BID #24-26-D04
Sitework and Structural for Downtown Campus
Addendum One
Released 11/26/2024

ADDENDUM: Addendum One addresses a process to request to be added to a prime/sub list for this project, questions and clarifications, a revised bid form, and drawings for DLC and DTC.

**Rock Valley College
New Downtown Campus
Sitework and Structural
Bid #24-26-D04**

Architect's Project Number: 23-030

SHEET NUMBER:
S1.00

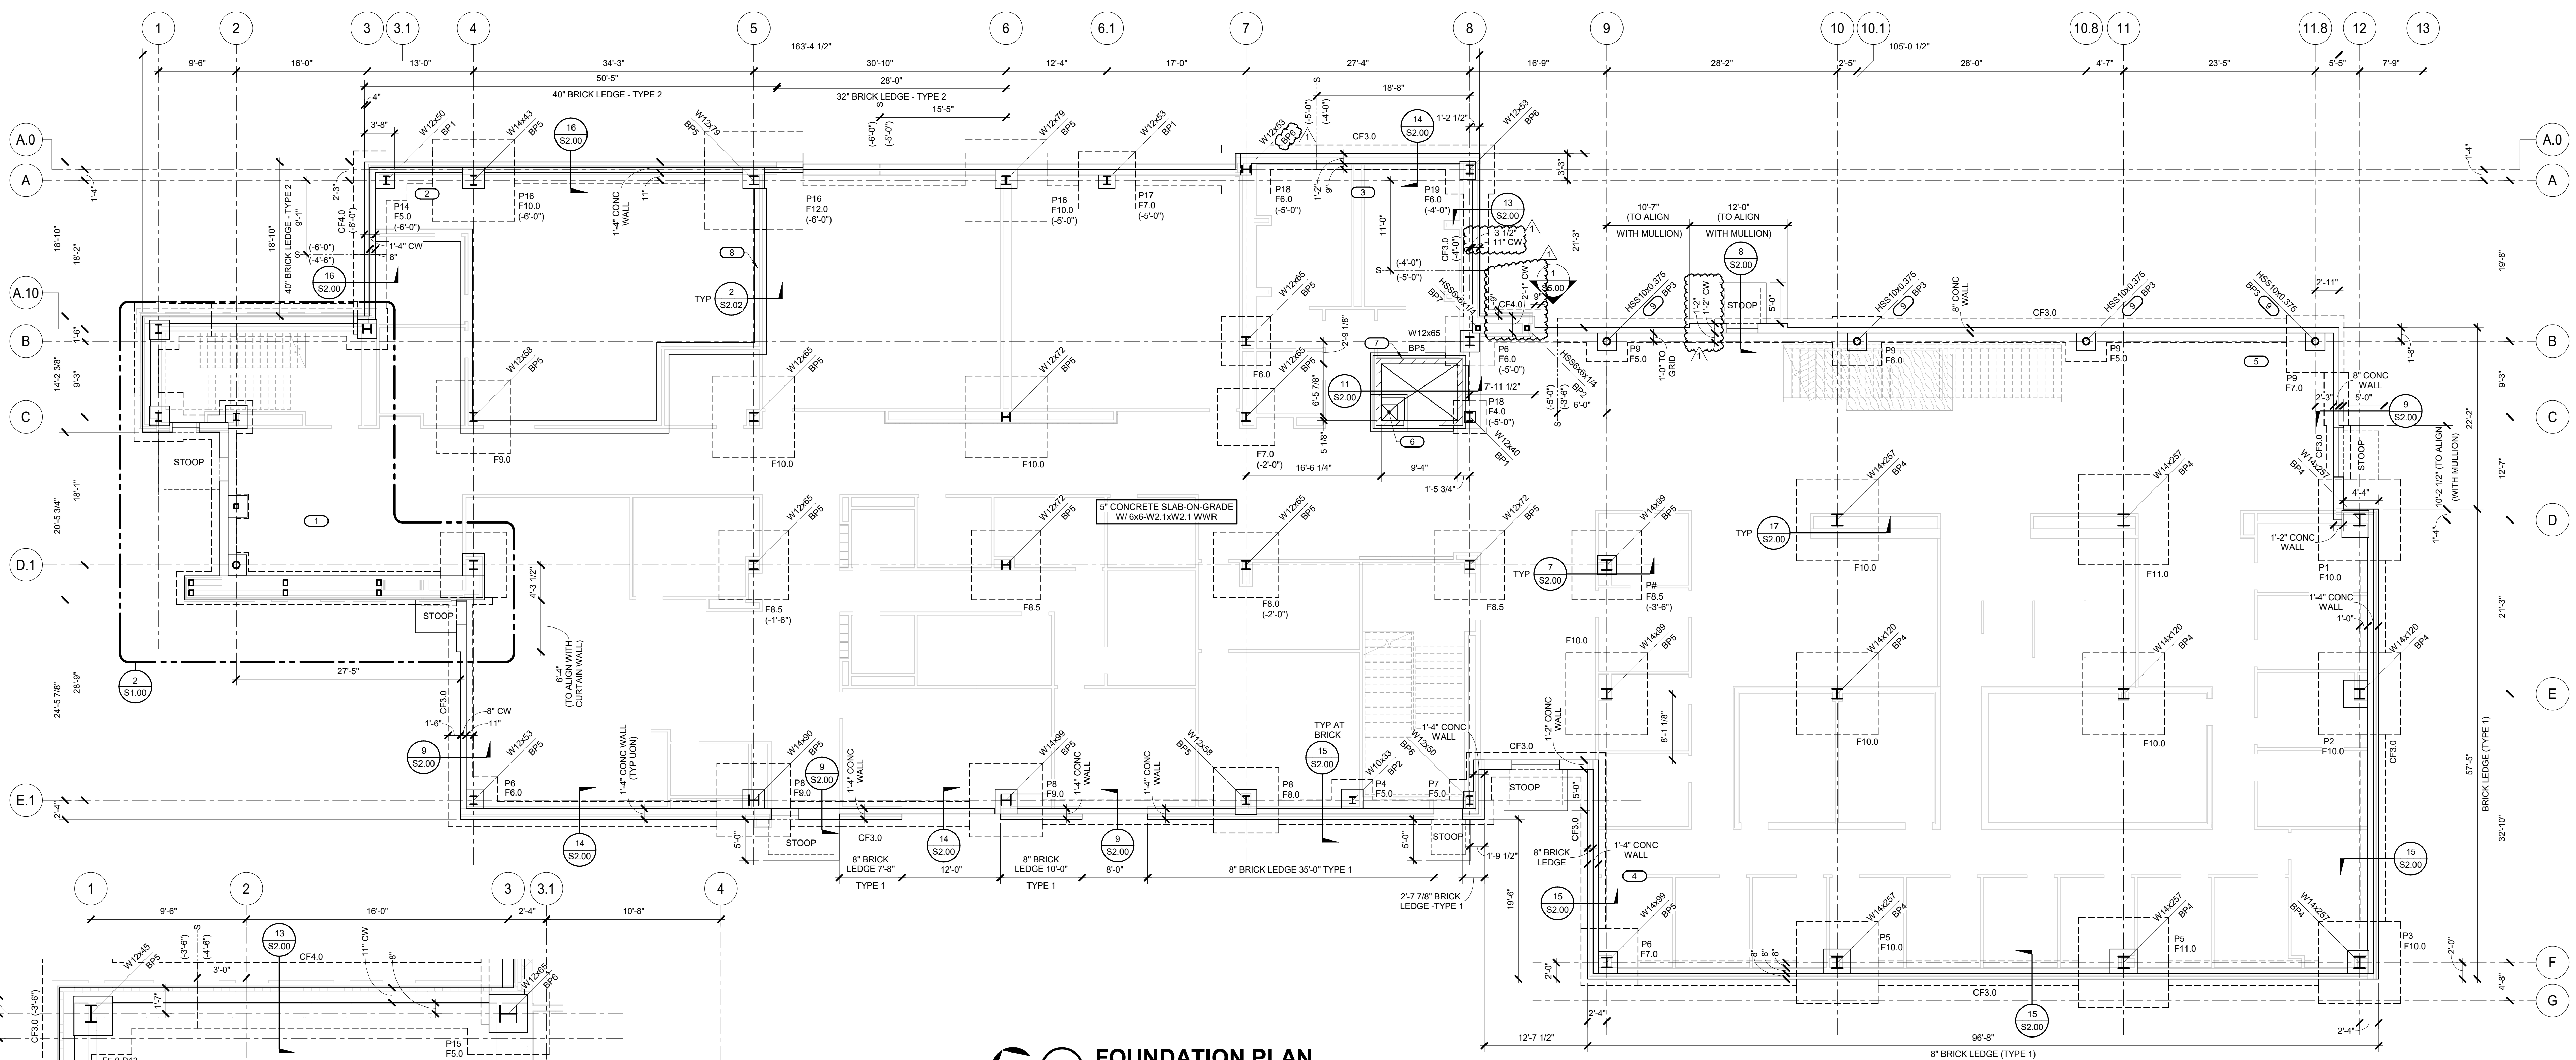
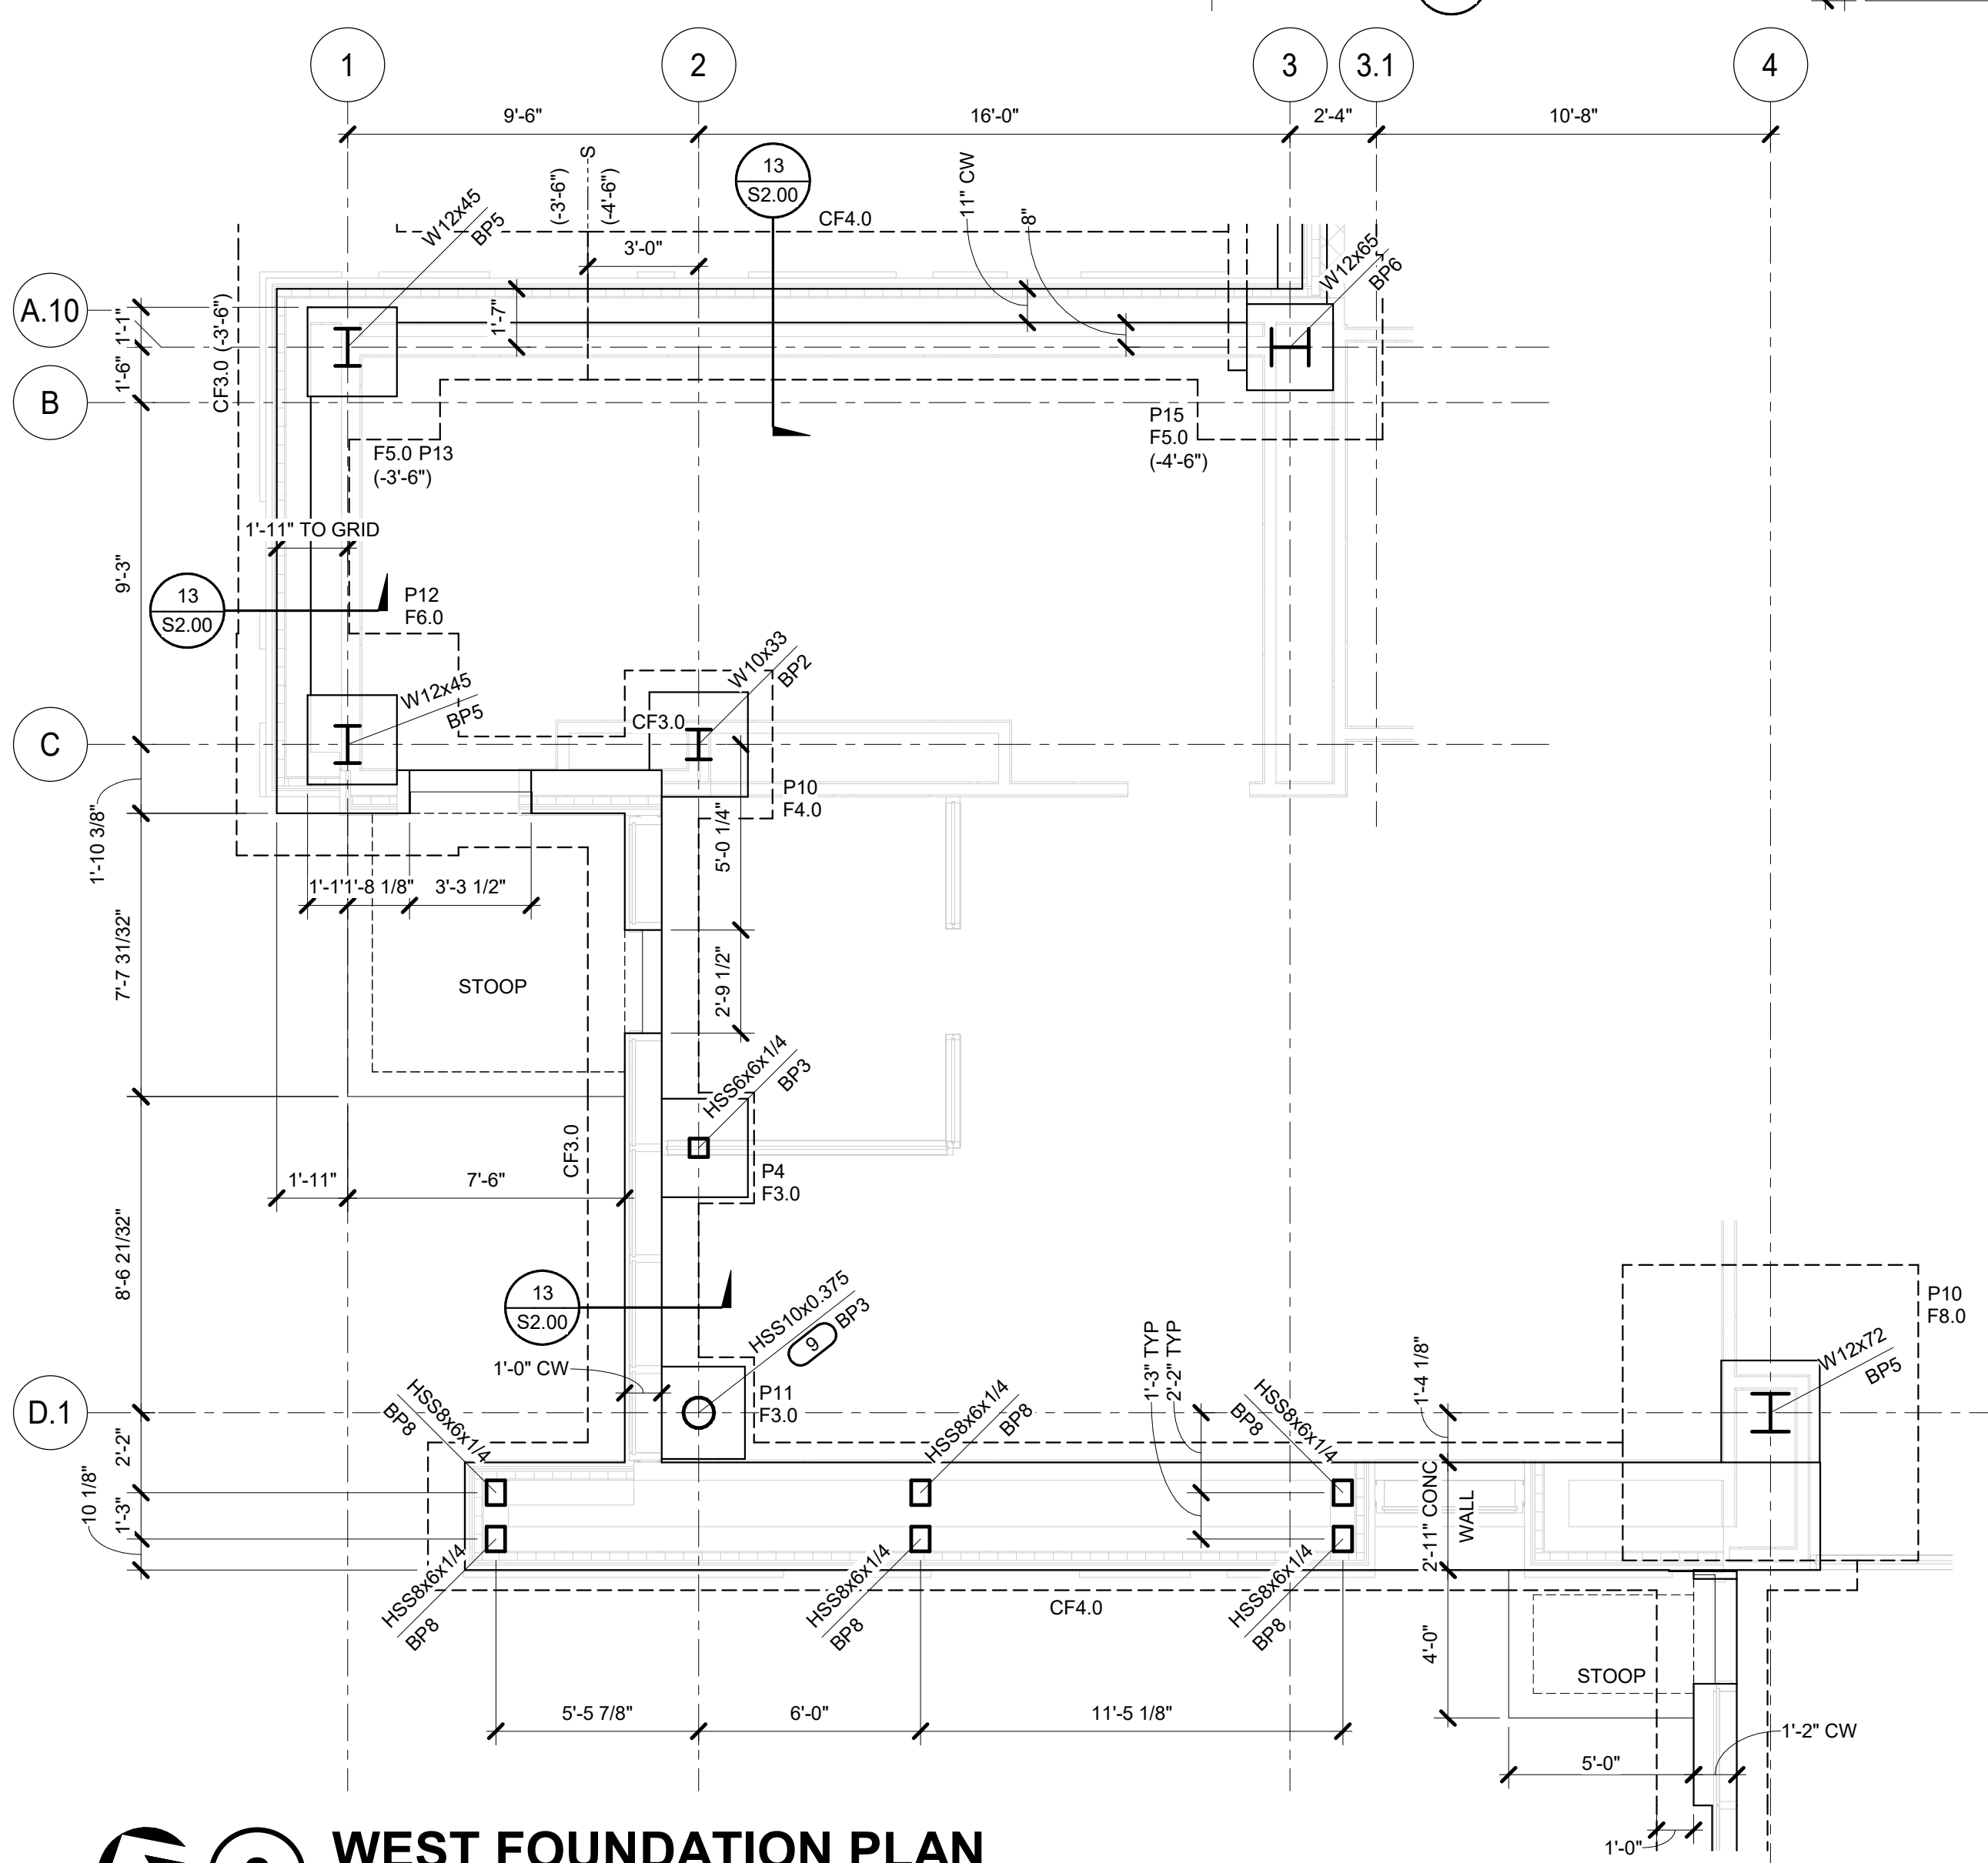
15. Sheet S1.00
 - A. Foundation and stem wall dimensions updated per arch request.
 - B. Column locations and amount at half height feature wall along Grid D.1 updated.

- C. Base Plate Schedule removed from foundation plan and information was distributed to the details (done to match DTC project).
 - D. Various footing reinforcement values updated.

SHEET NUMBER:
S1.01

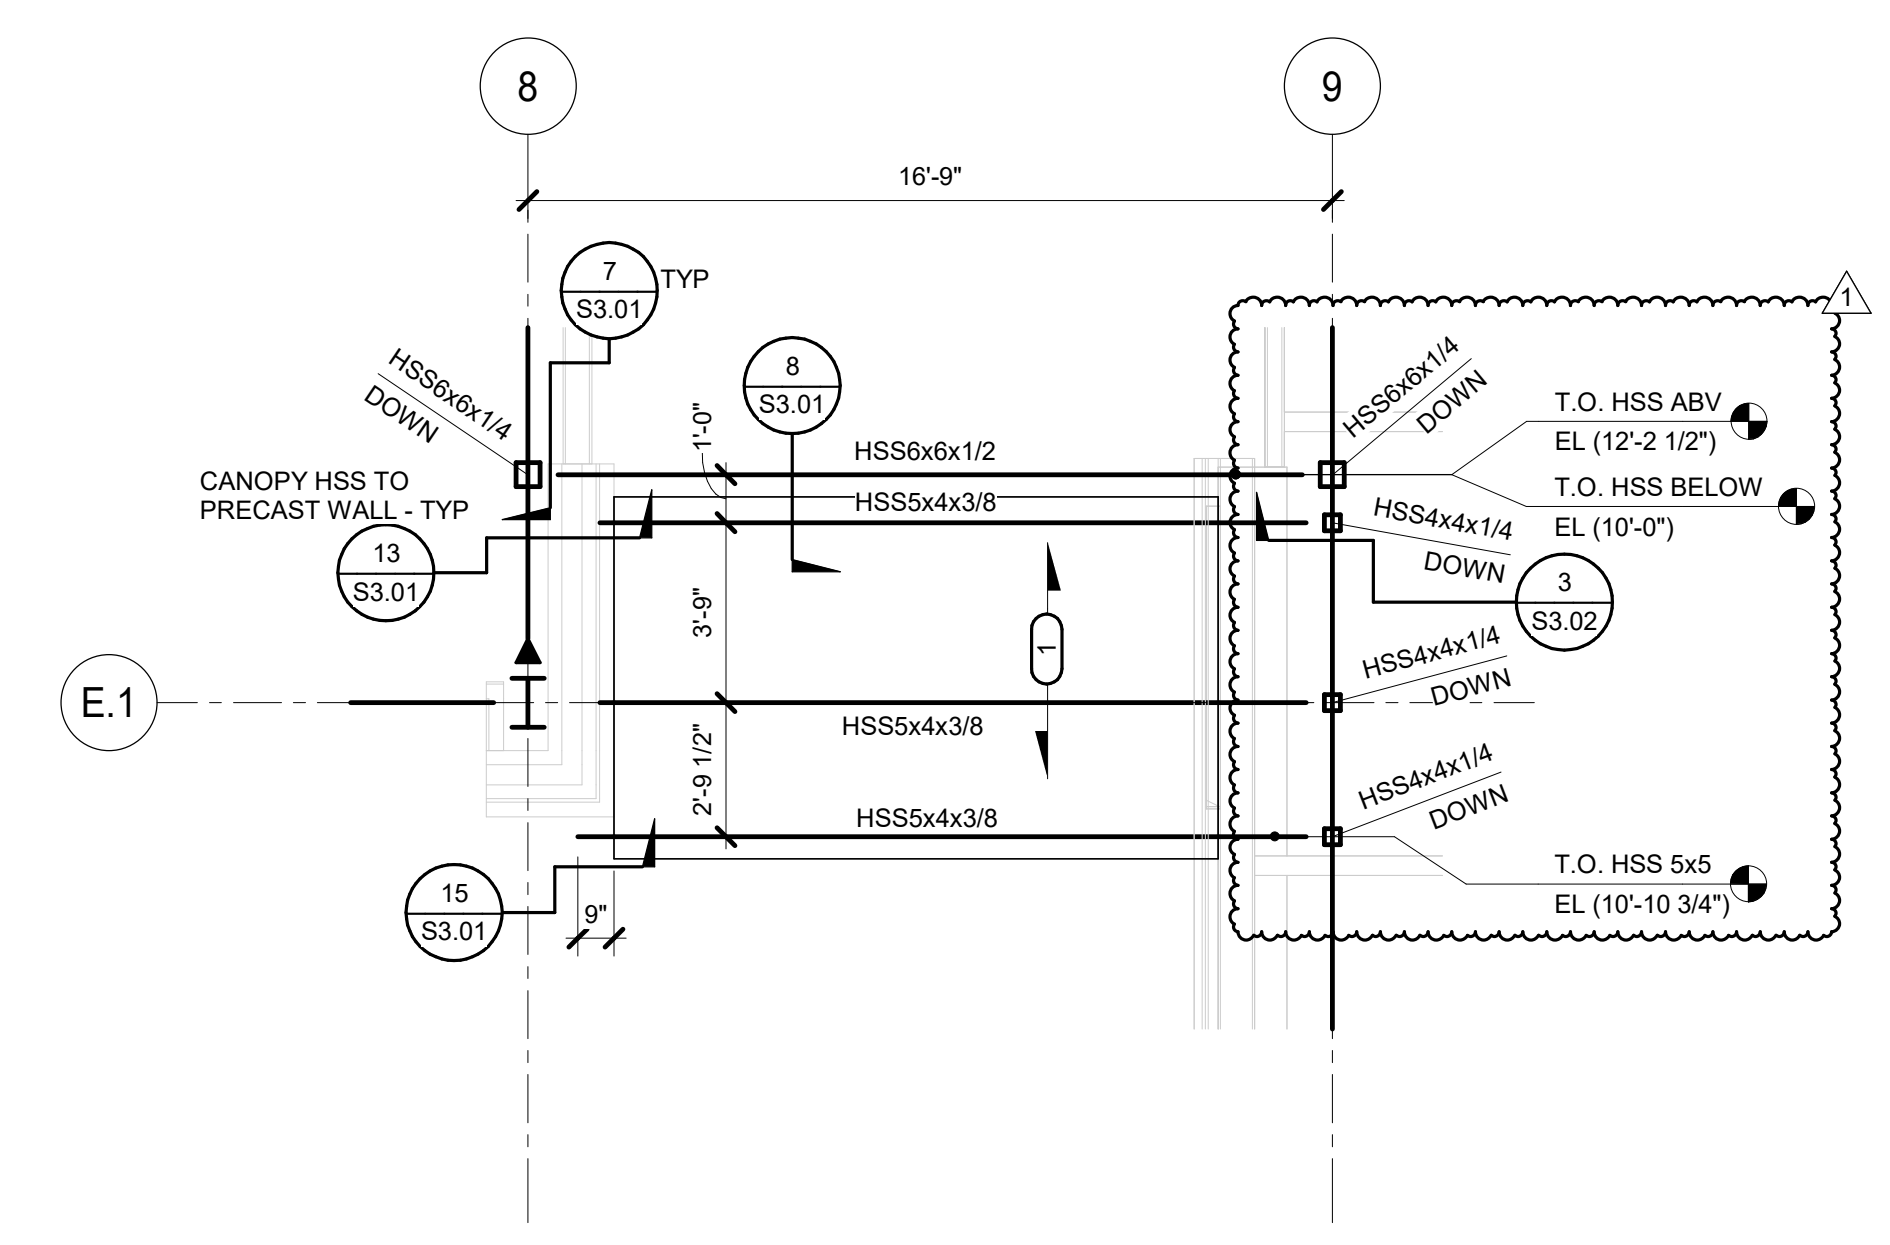
16. Sheet S1.01
 - A. Deck dimensions added around precast wall end adjustments (Grid A and A.0).
 - B. Detail callout and steel elevations updated at canopy framing, 2/S1.01.

- C. Detail callout 10/S3.02 added where precast façade wall is supported by steel framing.
17. Sheet S1.02
 - A. Beam sizes and connection adjusted to fit architectural sections (along Grid 13).
